NOV_SCE_IAG_20211117-04

NOTICE OF VIOLATION

Energy Safety Inspection Report

Report Name: IAG_SCE_20211117-04

Structure ID: X6067E

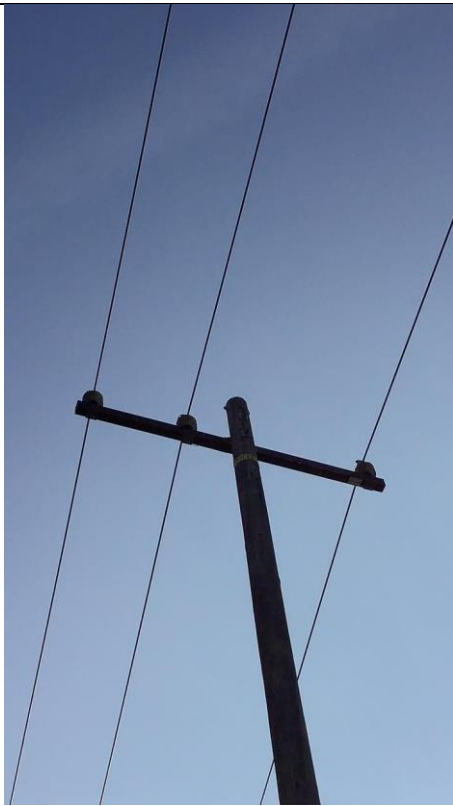
Item	Structure ID	HFTD	Initiative Number	Violation Type	Severity	Violation Description
1	X6067E	Tier 2	7.3.3.3.1	Adherence to Protocol	Minor	Failure to install vibration dampers on a span

Item1IA1Img1: No vibration dampers are installed
